# Product Modification Notice

## #16-CORP-01

Date: 08/07/2016  
To: Lumenera Customers  
From: Lumenera Corporation, Product Management  
Re: **IR/AR Filter Upgrade in Lumenera's Lt Camera Models**

### **IR/AR Transmission Values**

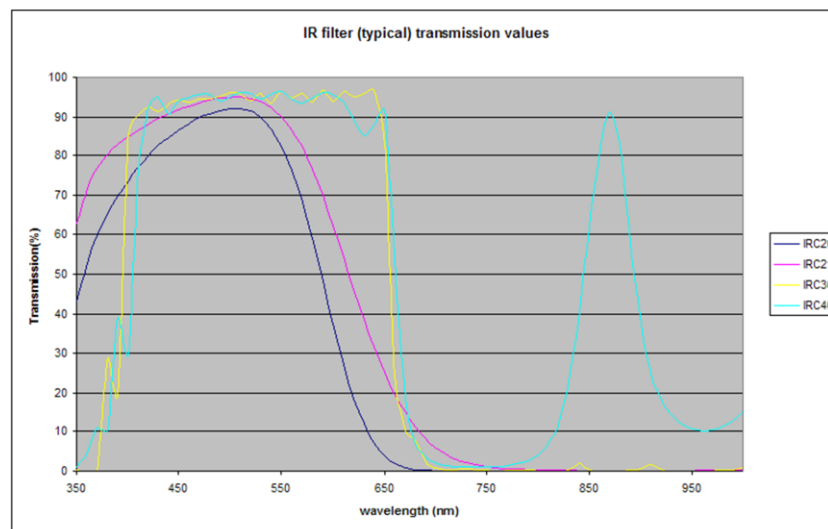
Currently these models only have an **IR** coating, and we will be transitioning to a new filter that has an **IR/AR** coating. This filter change will improve the camera's sensitivity, with an approximate 5% increase in transmittance.

REFER TO **IRC30** PLOT
